Gulfstream American

SERVICE BULLETIN NO. 162
"FAA (DER) APPROVED"

SUBJECT: REMOVAL OF CANOPY CABLE SYSTEM

SERIALS AFFECTED: AA-1B Serial 0551 and subsequent
AA-1C Serial 0001 and subsequent

Canopy Cable/Pulley System Removal
 Figure 1

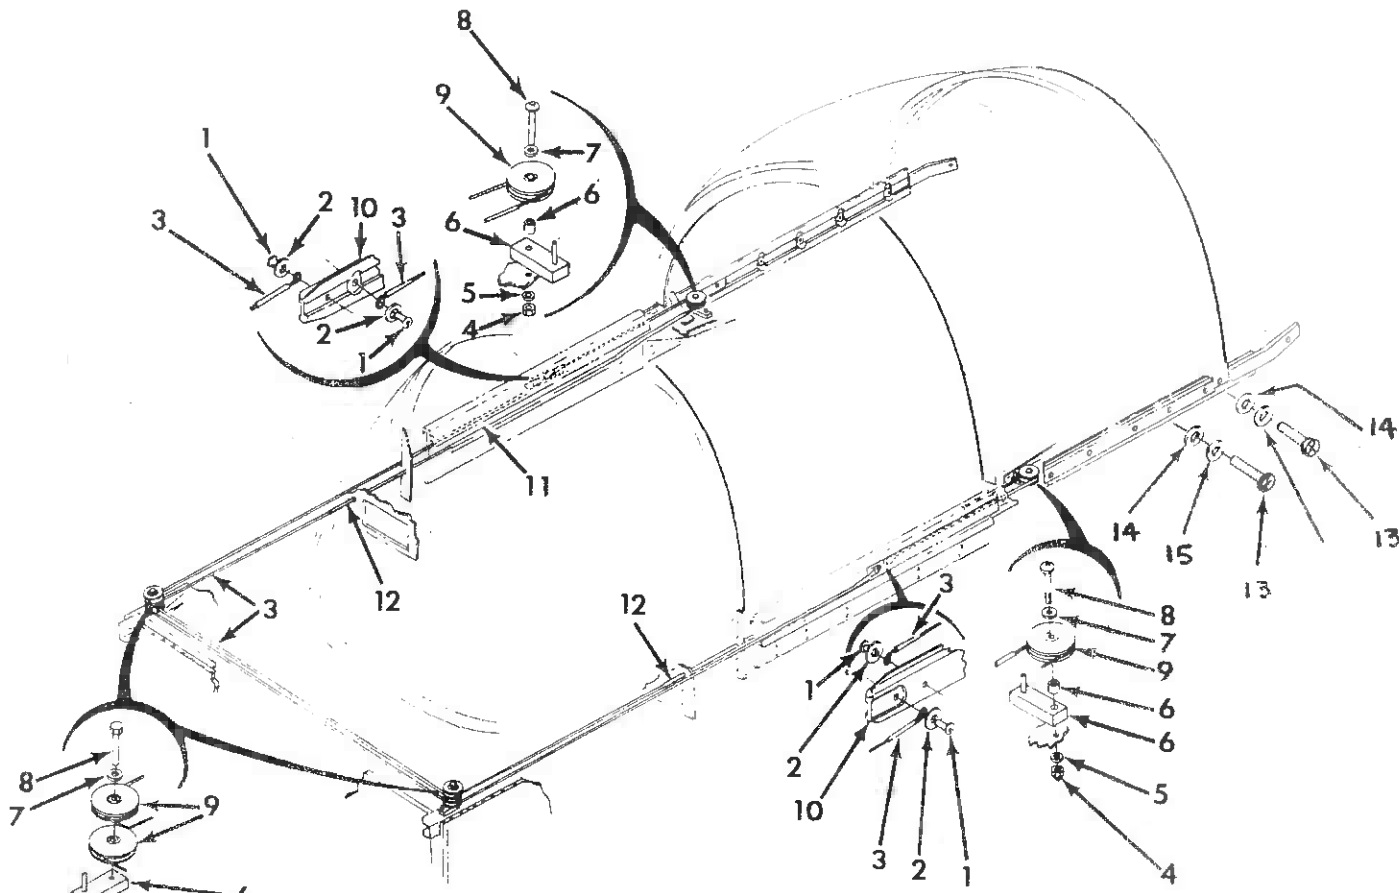
To eliminate excessive maintenance and replacement requirements and to prevent canopy jamming, the canopy cable system on those aircraft indicated is to be removed in accordance with the following procedure.

- (A) Remove canopy per following steps:
- a. Remove row of Phillips screws (13) and washers (14 and 15) on each side of canopy.
 - b. Lift canopy straight up and remove from aircraft.
- (B) Remove screws (1) and washers (2).
- (C) Pull cables (3) from pulleys and remove cables from aircraft.
- (D) Remove nuts (4), washers (5), spacers (6), washers (7), and bolts (8) securing pulleys (9), and remove pulleys from aircraft.
- (E) Rail lubrication

- (F) Reinstall canopy per following steps:
- a. Lower canopy straight down and align holes in canopy with holes in rails.
 - b. Install row of Phillips screws (13) and washers (14 and 15) through canopy in track and tighten to 10 ± 2 inch-pounds.
 - c. Open and close the canopy several times to distribute the lubricant which had been applied as per STEP 5b.
